**Consultations according to
the Environmental Code
Compilation 2009–2010**

Site for final repository selected, consultations concluded and licence applications submitted!

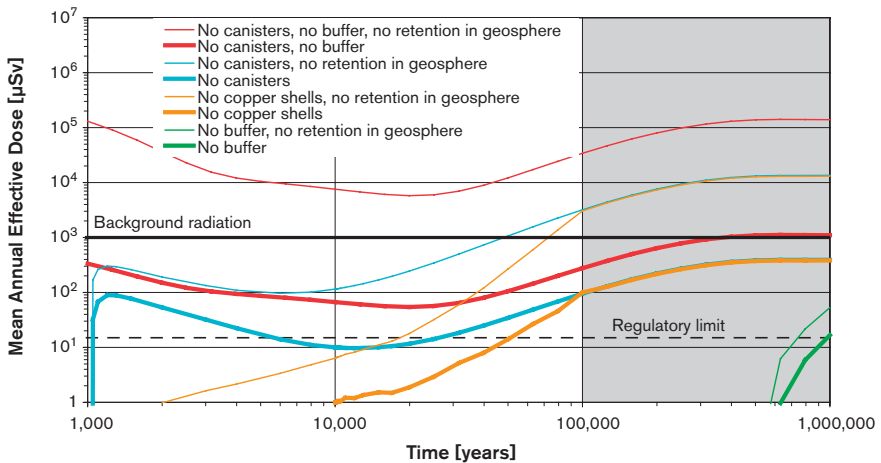
SKB has made calculations and illustrations of what would happen if there were no barriers. The thick red curve in the figure on page 70 shows what happens if the fuel lies naked in the rock. Appendix C from the meeting contains an excerpt from the Swedish summary of SR-Can describing results, in the form of annual doses, of calculations of different cases of defects in the barriers.

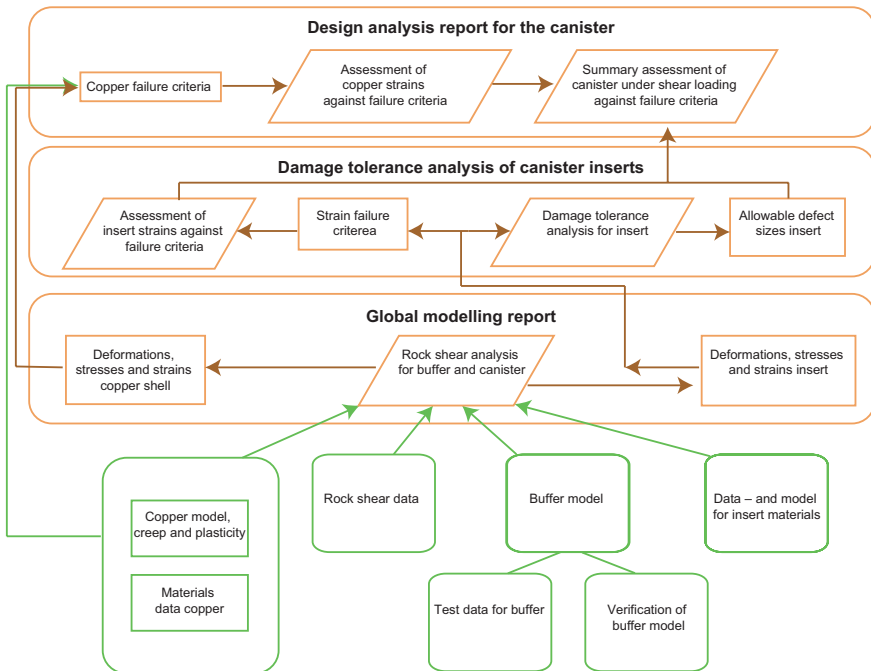
Shear load from earthquakes. Rock movements in fractures may not exceed 10 cm without jeopardizing the integrity of the canister. Results obtained suggest that the canister can withstand a shear of 10 cm without the breaking strain of either the copper shell or the cast iron insert being exceeded. Material tests have shown lower values of breaking strain for the insert than the required 7%. Values down to 2% have occurred. SKB presumes that this is due to casting defects in the form of slag inclusions. The regulatory authorities state that SKB should present better analyses and investigations that verify that the actual breaking strain is not exceed for the cast iron insert at a shear of at least 10 cm. If this proves impossible, the criterion should be reconsidered.

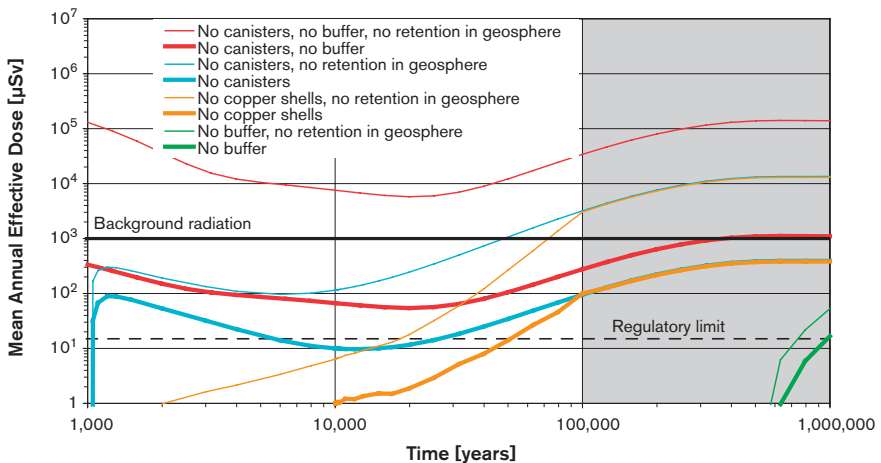
The results of the defined cases are shown in the figure on this page. The thick red curve shows what happens if the fuel lies naked in the rock.
